Staff recommends that the Historic Preservation Commission **approve with one (1) condition** the HAWP application:

Re: Historic Area Work Permit for
7318 Willow Avenue, Takoma Park Historic District
Addenda to HAWP: **Written Description of Project**

BURNELL-VIRK ADDITION

7318 Willow, Takoma Park, MD 20912
Project # 2180

Figure 2: 1959 Sanborn Map showing the subject property before the rear addition was constructed.

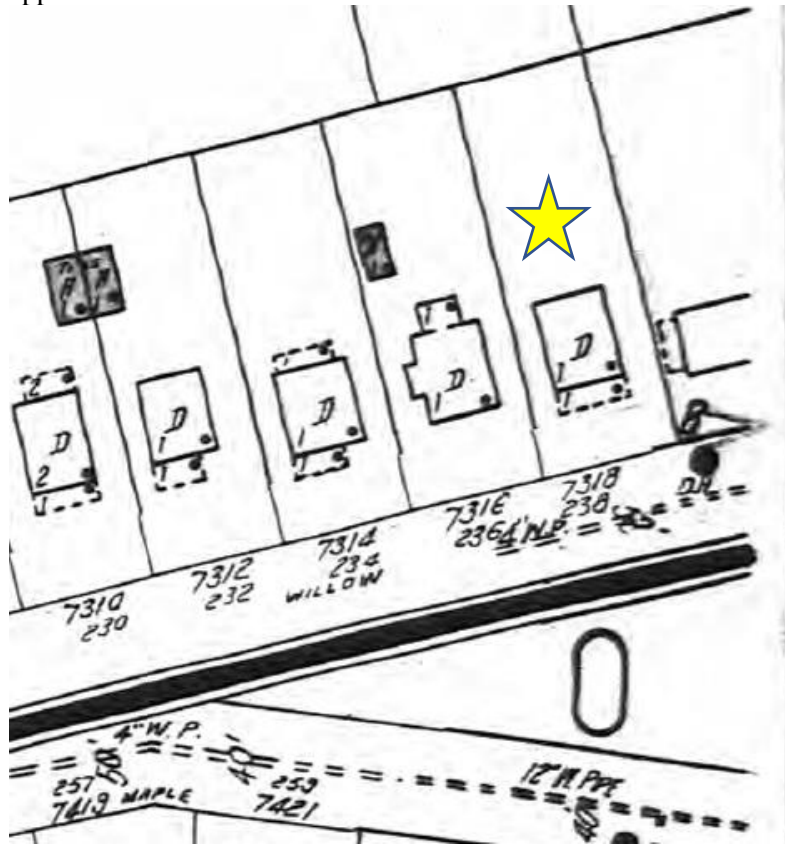
The Takoma Park *Design Guidelines* state that major additions, where feasible, should be placed to the rear of the house to minimize their visibility. However, Staff does not find the proposed mudroom addition necessarily qualifies as “major” and that additional considerations are warranted in evaluating this portion of the proposal. Staff finds the materials, are compatible with the existing historic house and surrounding district. Staff also finds that the addition’s style is consistent with the Craftsman style of the house, per the *Design Guidelines*.

In speaking with the project architect Staff learned there were three primary reasons why the proposed mudroom projects to the side. First, the goal of the proposal is to optimize the floorplan in the rear of the house. Second, by placing the mudroom to the side, the proposal would avoid any impacts on the very large tree to the rear of the house. Third, the design team recognized the mudroom would connect to the house adjacent to a non-historic addition, so they could construct the addition without destroying historic fabric.

While Staff does not find optimizing the interior floor plan to be a justification that the HPC can rely on, Staff finds the other two justifications should be considered. The character of the Takoma Park Historic District includes the mature tree canopy and park-like setting of the district as a whole. The existing tree is quite large and appears to be healthy. Constructing the rear addition (discussed above) on piers and placing the mudroom away from that tree will avoid impacting the tree's critical root zone. Staff also finds that because the addition will not impact historic fabric and could be removed in the future without impairing the character and materials, its design satisfies the requirements of Standard 9 and 10.

Other factors Staff considered include the substantial distance from the right of way to the proposed mudroom, 81' 6". Staff finds this distance will lessen the addition's visual impact so that it will not impair the character of the surrounding streetscape. Staff recommends the HPC approve the mudroom addition and stoop under the *Design Guidelines*, Standards 9 and 10, and 24A-8(d).

Detail: PRECEDENT: SIDE BAY BEHIND CHIMNEY

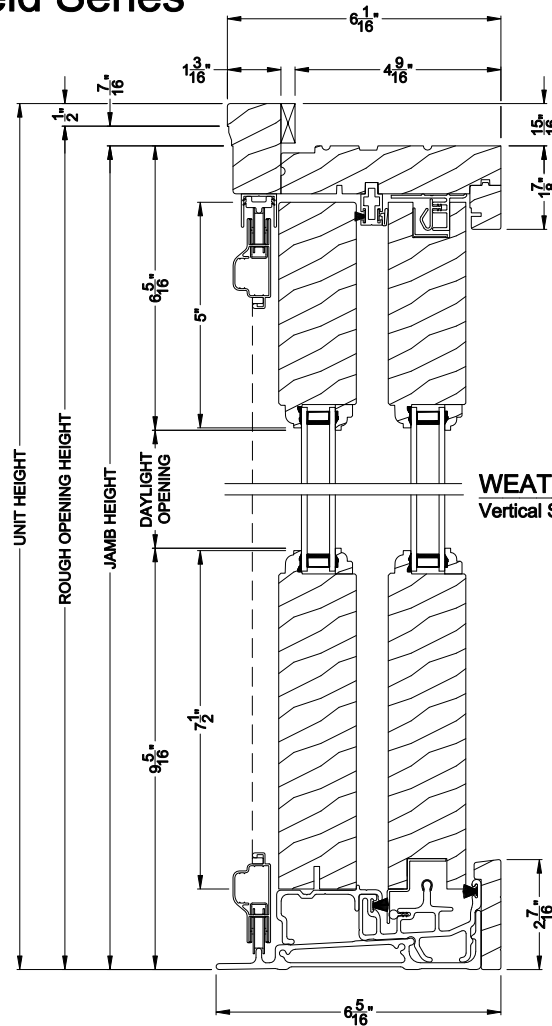
On the left elevation, behind the existing chimney, the applicant proposes to construct a bay with a shed roof, with exposed rafter tails. The materials for the proposed bay will match the existing house including, wood siding, asphalt shingles. The historic paired six-over-one windows and trim will be reused in the new bay. The new bay will be 2' x 11' 5" (two feet wide, by eleven feet, five inches deep), which matches the projection of the chimney.

Staff finds that rectangular projecting bays are typical of Craftsman houses; and that this feature is compatible with the architectural style of the house. Staff also finds that reusing the paired windows in the bay will maintain the window opening size, per the *Design Guidelines*. Staff recommends the HPC approve the new bay under the *Design Guidelines* and 24A-8(b)(2) and (d).
